Objections and comments on the planning application at 84-90 Lordship Lane London Se22 8HF. Reference 14/AP/0280.

Report written by [REDACTED]

1.00 Introduction.

Image 1 Item A Melbourne Grove junction with Chesterfield Grove. Item B Lordship Lane junction with Chesterfield Grove.

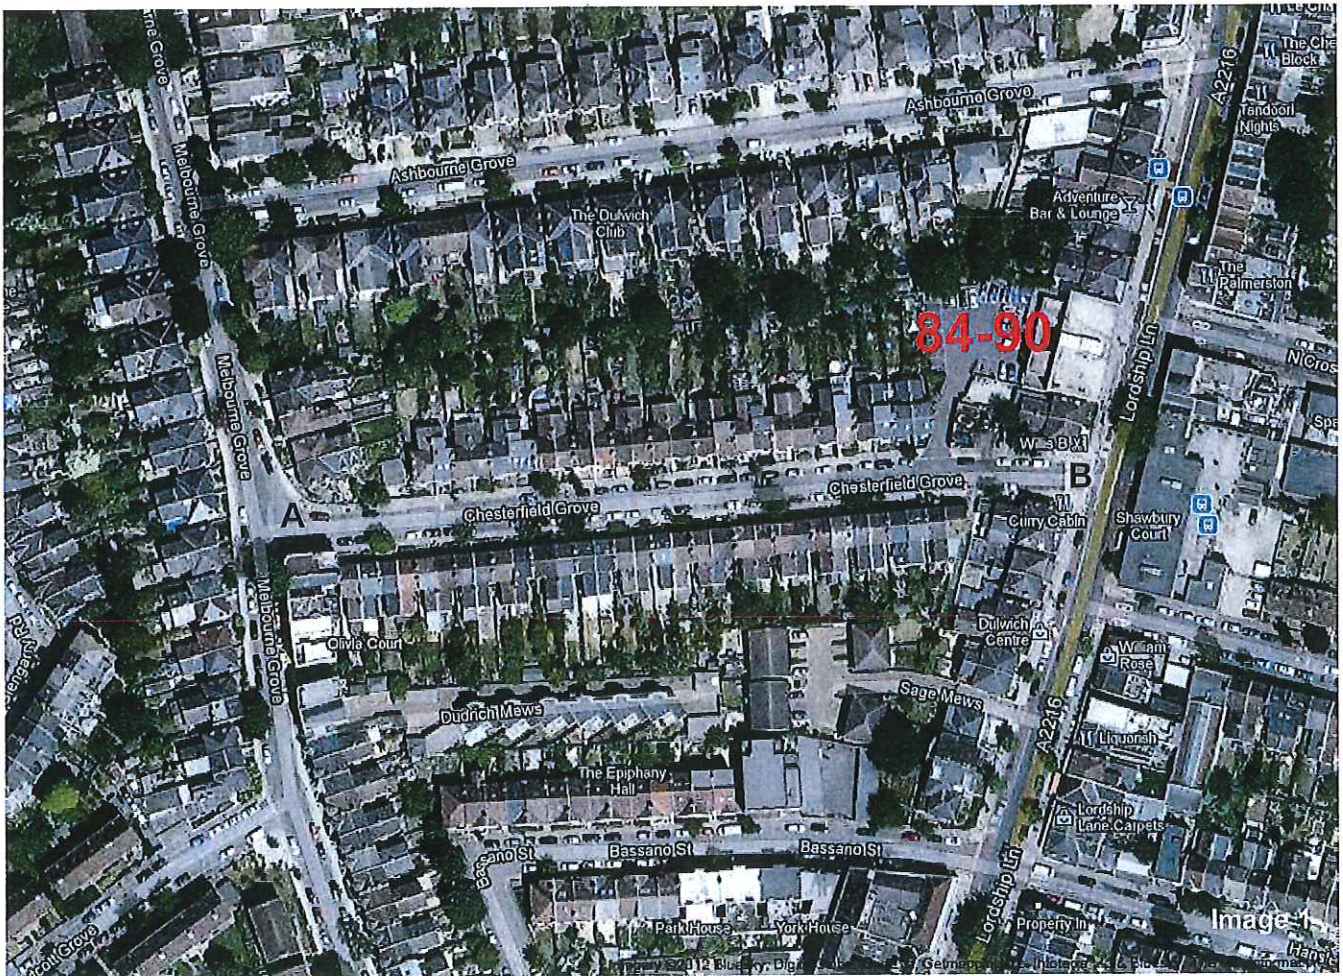
1.06. Iceland vehicles always try and approach the site from Melbourne as mentioned above. There also a benefit that junction between Chesterfield Grove and Melbourne Grove is wide and will allow the lorries to turn around, unlike the restricted junction off Lordship lane see image 1.

Image 2

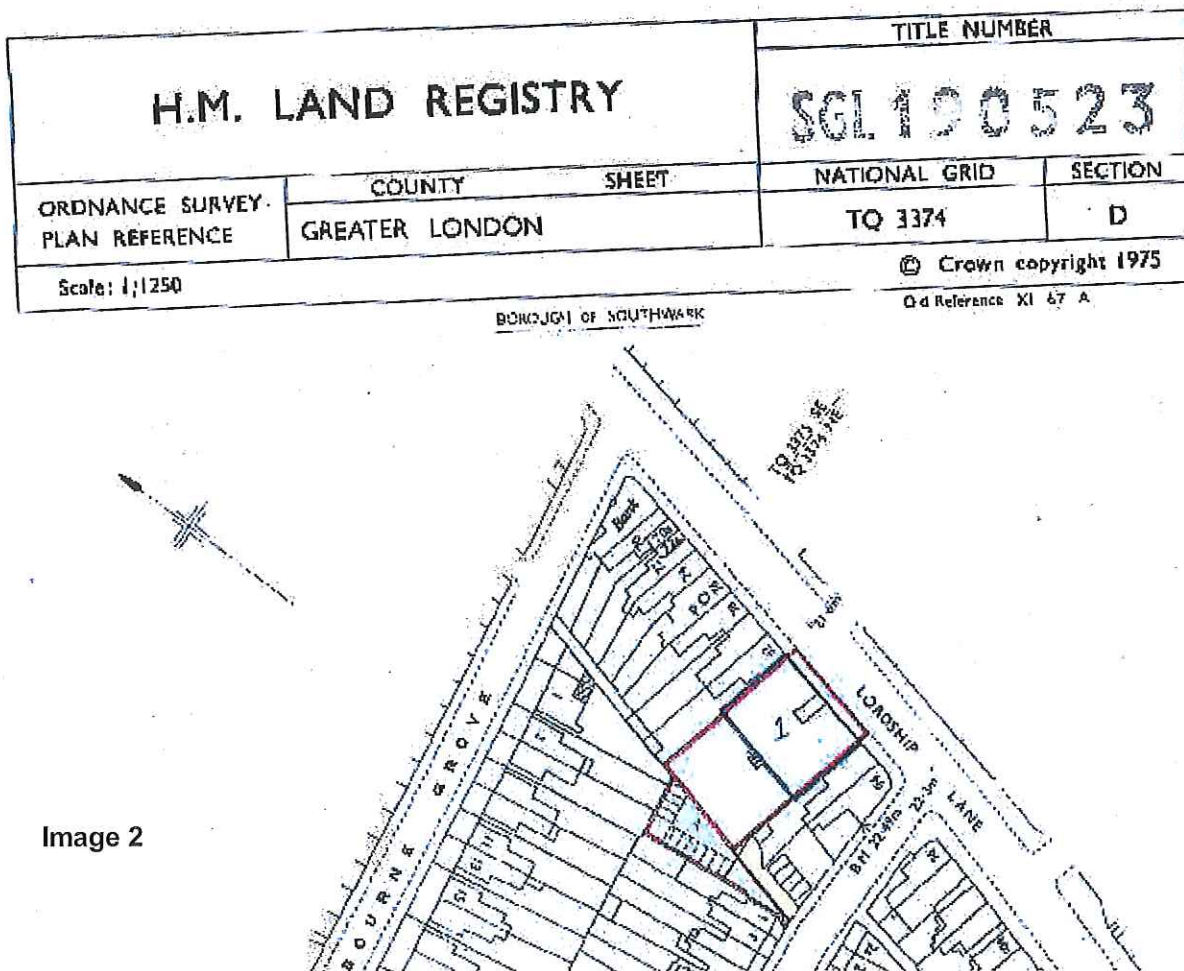
3.01. Image 2 below shows an extract of the plan from the registry land title to 84 to 90 Lordship Lane, title number SGL 190523. It shows the title comprises of two parcels of land, a rectangular area edge in red, and a triangular piece of land edge in red and lettered A. Land registry have confirmed that area lettered A refers to all of the triangle as coloured blue. The area A was added to the title in April 1982. I believe the reason for this was the application made 1974 included part of rear garden [REDACTED] No 1 Chesterfield Grove, a line can be seen in the plan below, but this did not receive planning approval, and as works had commenced on this development some of the built works had to be amended, and it probably took until 1982 to sort out both a new planning application

Image 6

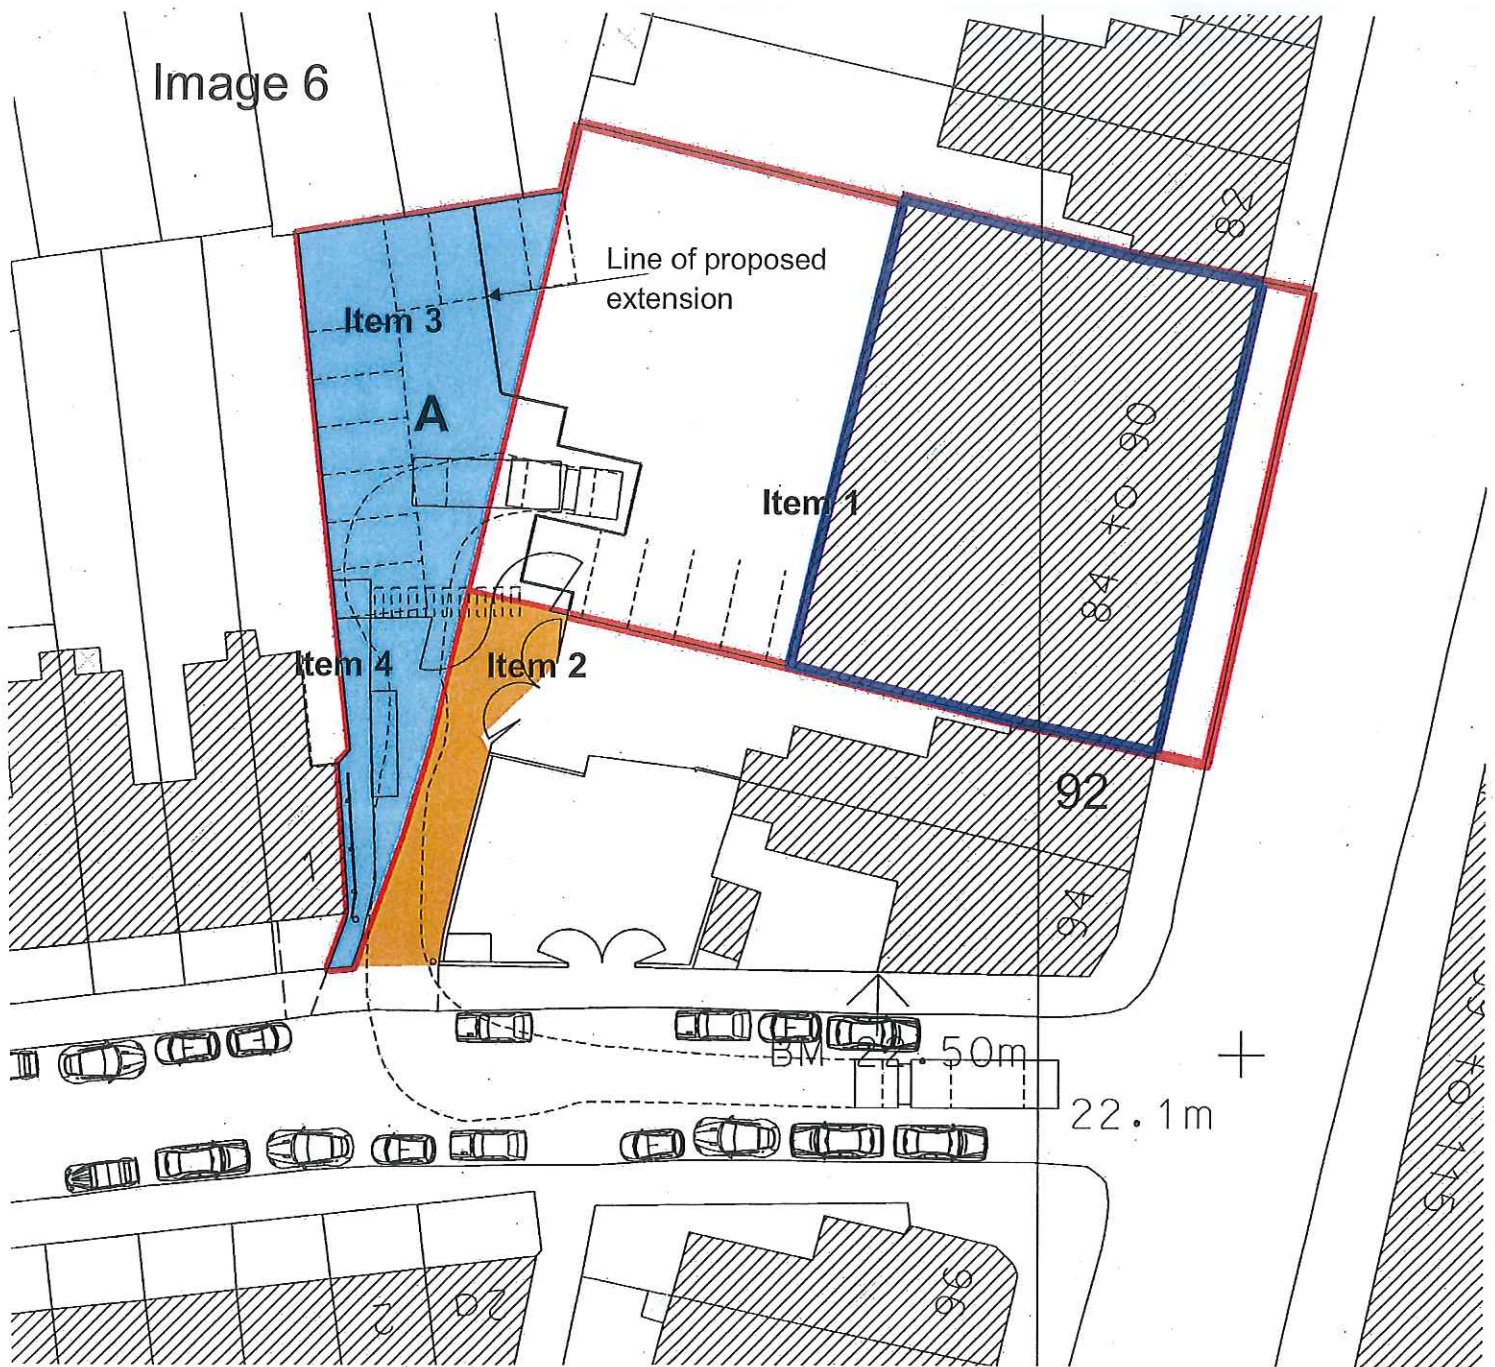
3.06 Image6. The existing access to the land marked item 11 edged in red, is via 2 (tinted brown) and through the present gates. There is no right of way granted over land tinted brown (2) to land lettered A (tinted blue). The applicant should provide a design for planning that complies with this legal requirement, and that had been established on older registered titles as discussed in section 3.03. The access to land A by vehicle is only from the rectangular area item 1

Image 7

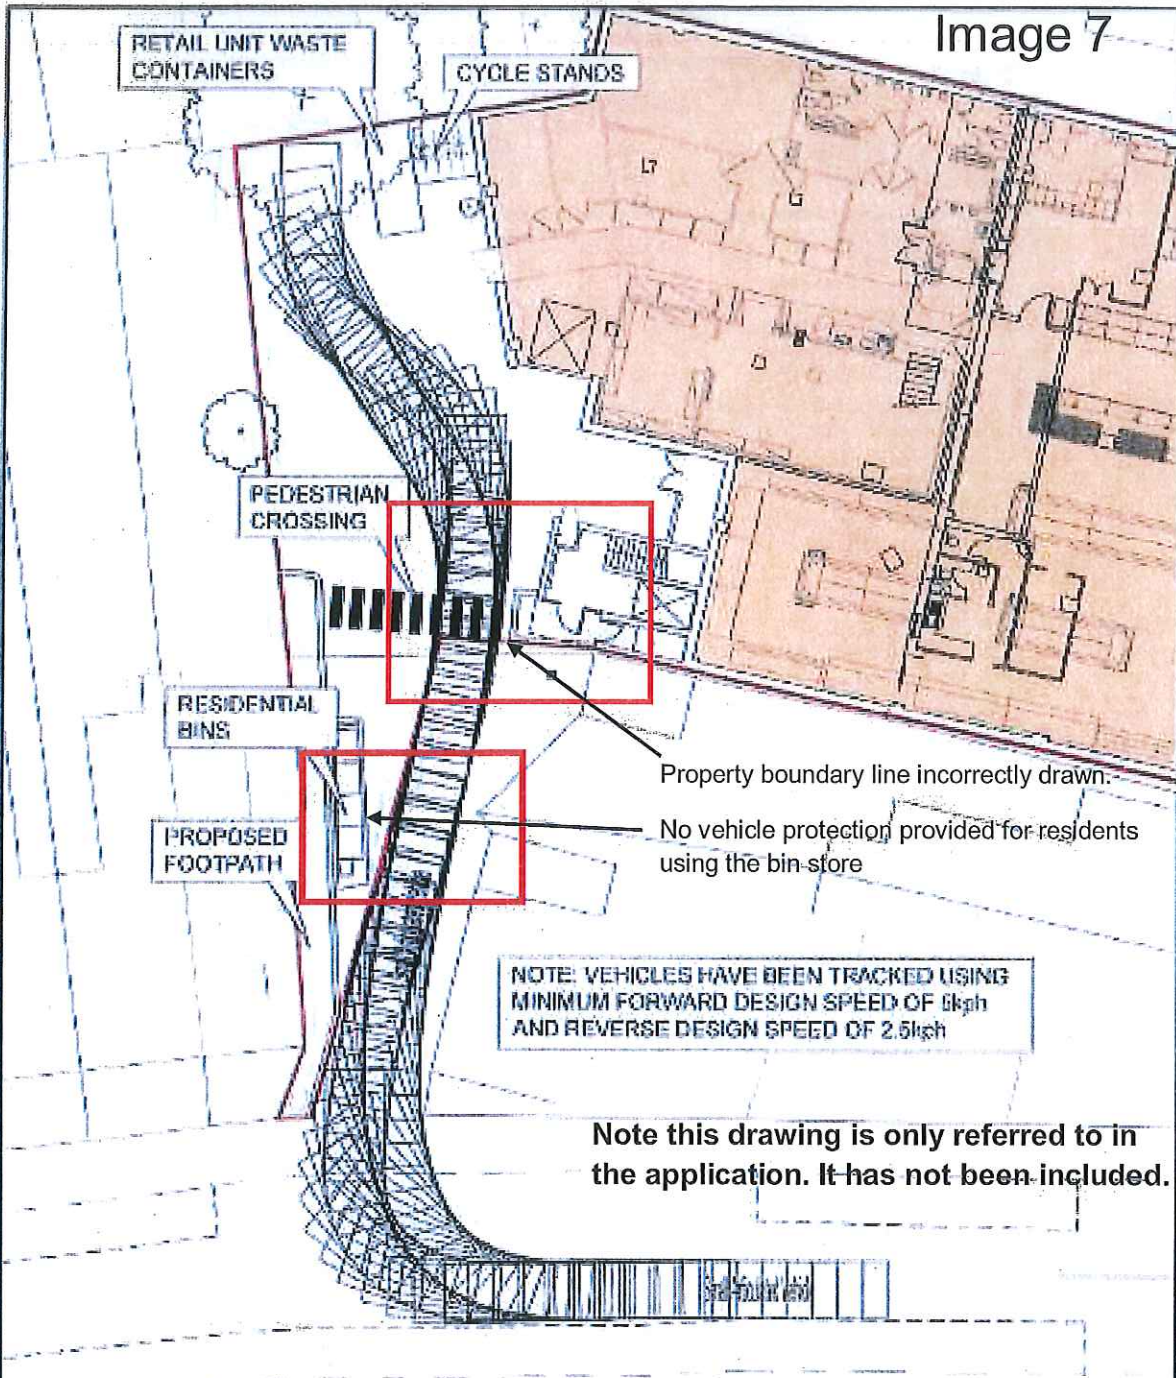
3.07 Image 7 on the next pages shows the current over optimistic swept path. This is only referred to in the application. The red line boundary shown on this drawing is incorrect, The vehicle is shown accessing the parcel of land marked A from tinted brown area, that has no rights of way to, as item 4 recorded in the property register. Ironically the present way the site is accessed is via Melbourne Grove, and this manoeuvre would comply in part with property title restrictions.. The restricted access to the bin stores, and the danger that people face when using them from vehicles hitting them because of the lack of room, has been ignored by the traffic engineers drawings, this will discussed later in the document, section 4 and 8.

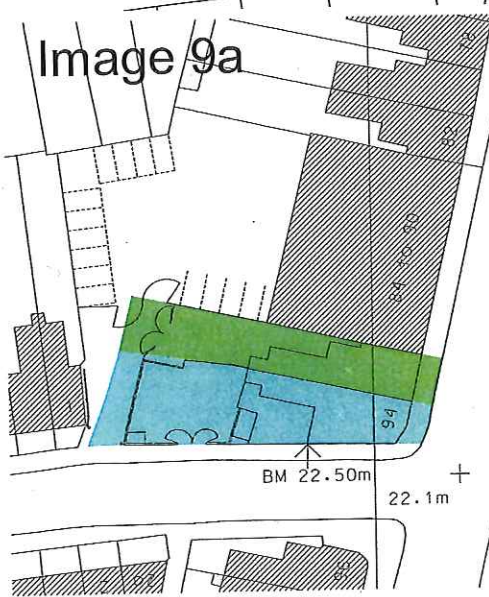
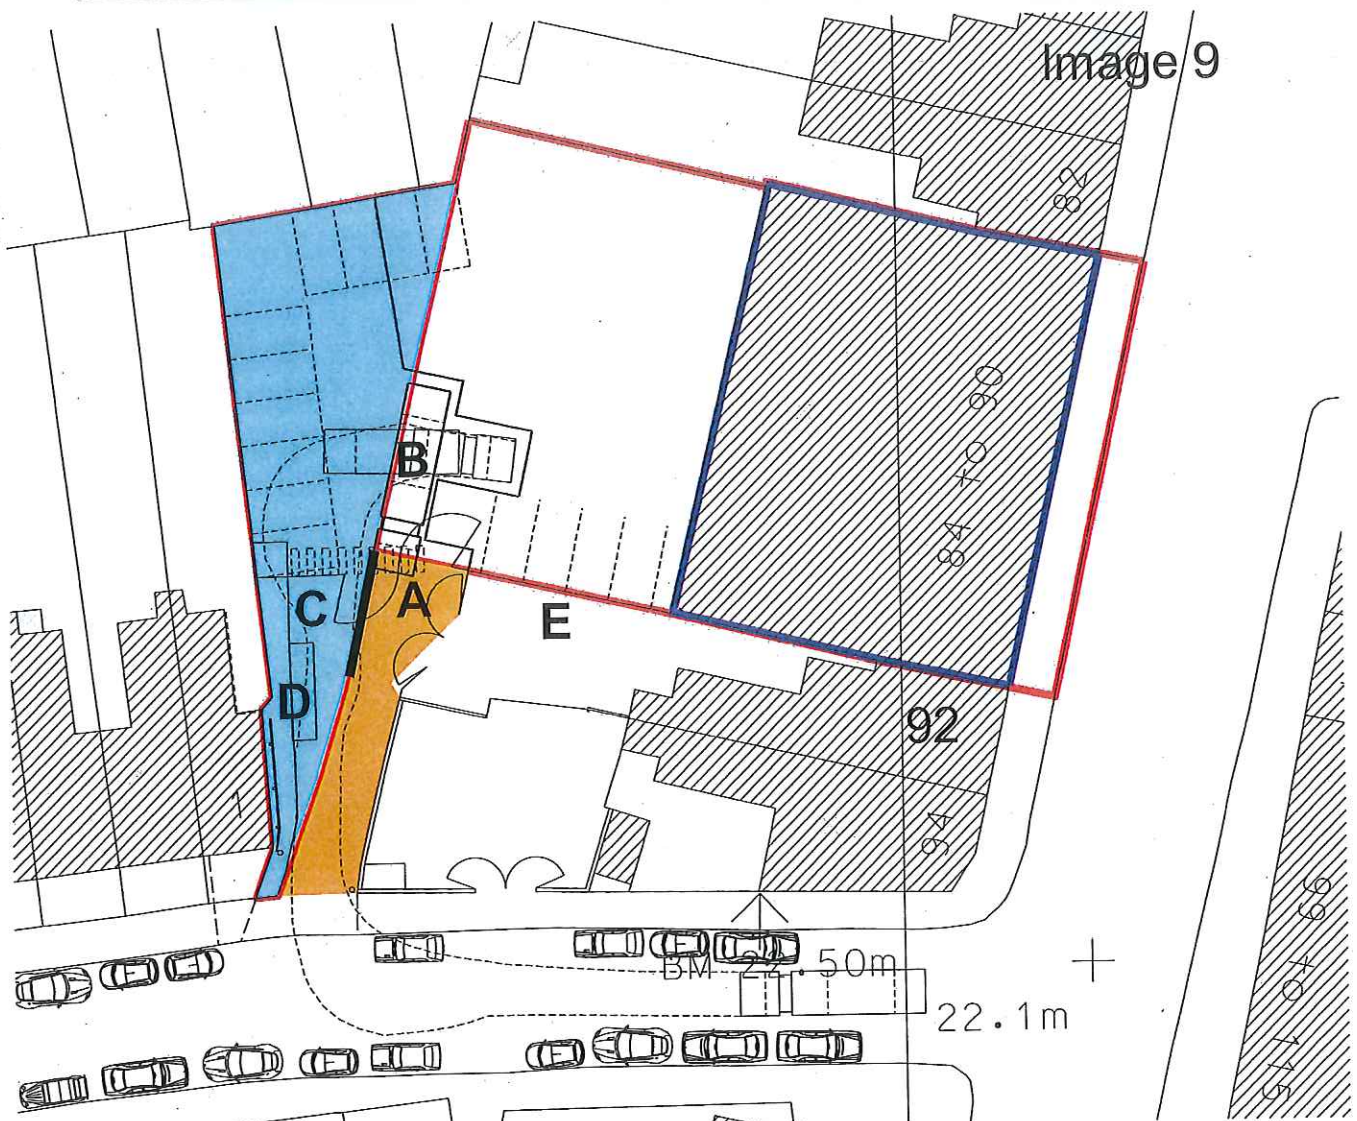
3.07. Image 8 above shows the shutter access to the goods storage. Drawing 1121/P (-) 110 rev P3 notes that there is scissor lift located behind the shutter as required by M&S. For lorry to use this it would have to reverse up to shutter as shown above in image 7. it is noted that vehicle is located such that it blocks access to the flats, and sits on land that only has rights of access over. Also I believe the shutter area is too small to include bollard protection that is an M&S requirement. The architectural drawing should be re-issued to show a vehicle using this shutter with sufficient room for building protection, and not block or endanger residents using the entrance to the flats. To do this would mean the back of house area to the M&S unit would be greatly reduced and no longer fit the store criteria.

3.08. The entrance area shown on all the drawings issued with this application are in correct and misleading. The information shown on my drawing reflects existing conditions for example the gated entry to number 92, and the removal of the old shed to number 92 are all shown, I would expect the same level of information shown on the applicant's drawing

Image 11

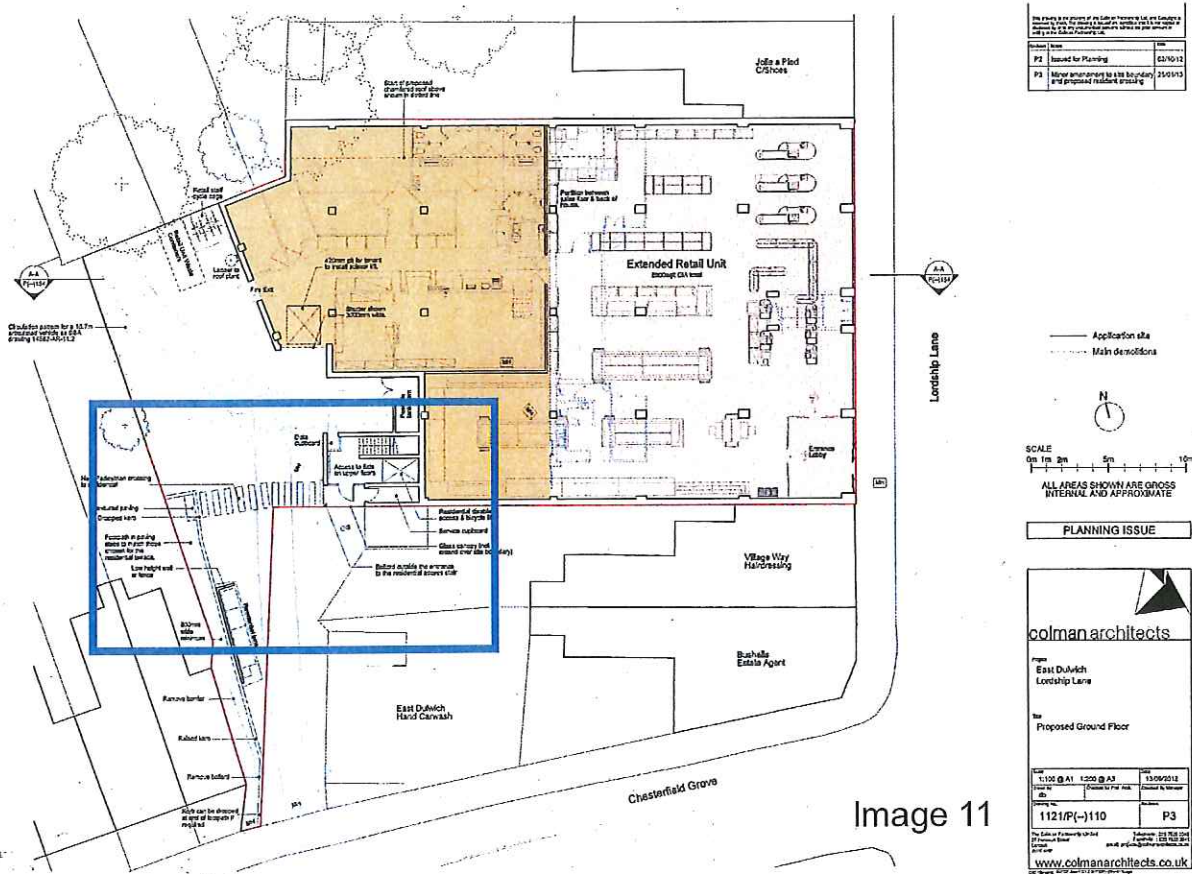
4.02. Item A is an objection to any work being constructed on there land. Drawing 1121/P(-)110 rev P3 (see image 11 on page 17) has been amended from refused application all works is now on the applicants land They also require the entrance of the flats to be located away from their rear vehicle entrance to there property. They consider there is possible risk of residents walking into there entrance and being hit by a car reversing out.

5.02. Drawing 1121/P(-) 110 P2 has the red line property boundary incorrectly shown for 84 to 90 lordship Lane. The applicant has shown works on land that do not own. This has been objected to by the owners of number 92, see section 4.02. Image 11 shows an extract of this drawing below that highlights the error. This drawing should re-issued with the correct title boundary shown on with all items raised in section 4 addressed, as they are mostly to do with title boundaries and rights of way. They must ensure that this drawing reflects accurately the items recorded in the property register for title number SGL 190523, as raised in section 3.

Image 19. Item A shows the drop kerb and where the footway stops. Item B shows the bollards. Item C is right way on foot. Item D, the adjacent arrows indicates the blind spot to vehicles

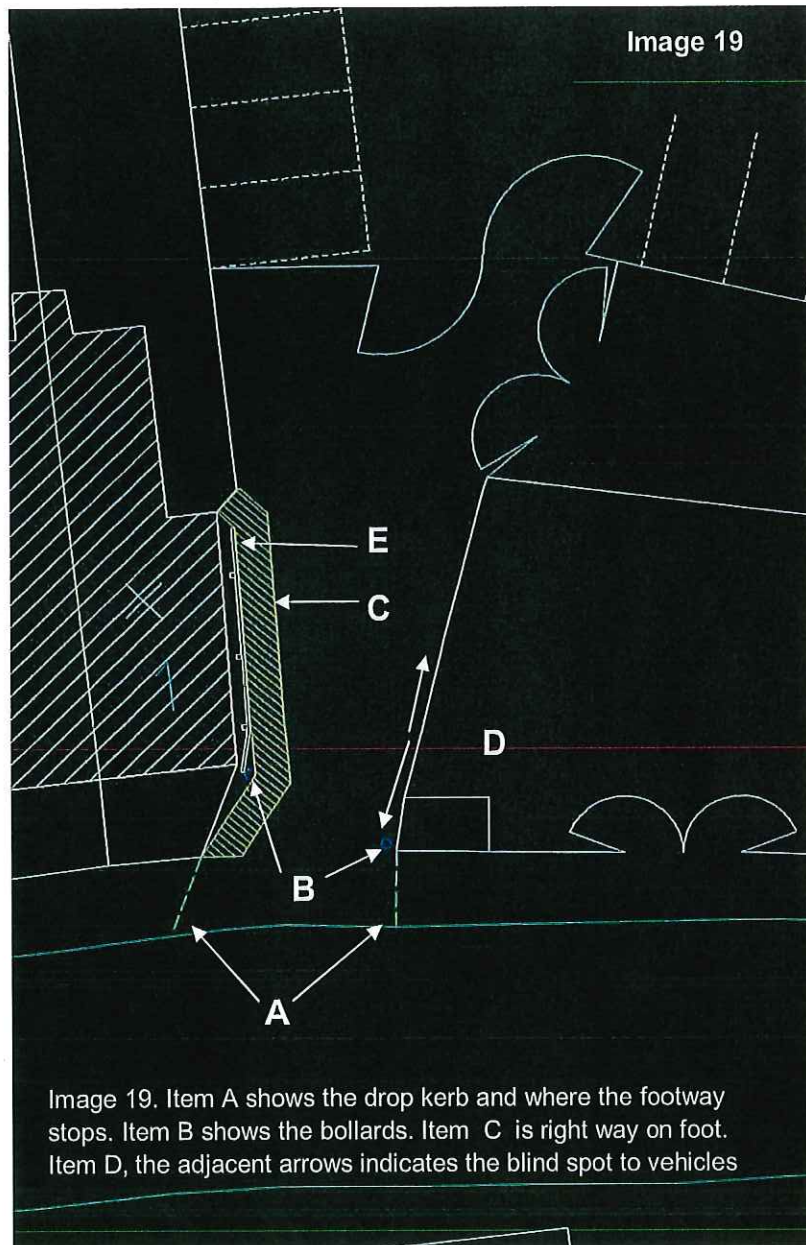
7.03. Item B the bins can only taken to Chesterfield Grove, down the path runs along the boundary of my property, as they have no right of access from this land to area tinted brown as discussed previously. I would therefore object to the additional noise that will created when they are move for collection. The other issue is that there is no nearby for the local authority to collect them, except Chesterfield Grove, but this would simply clutter the pavement and make it impassable see item C on image 17.
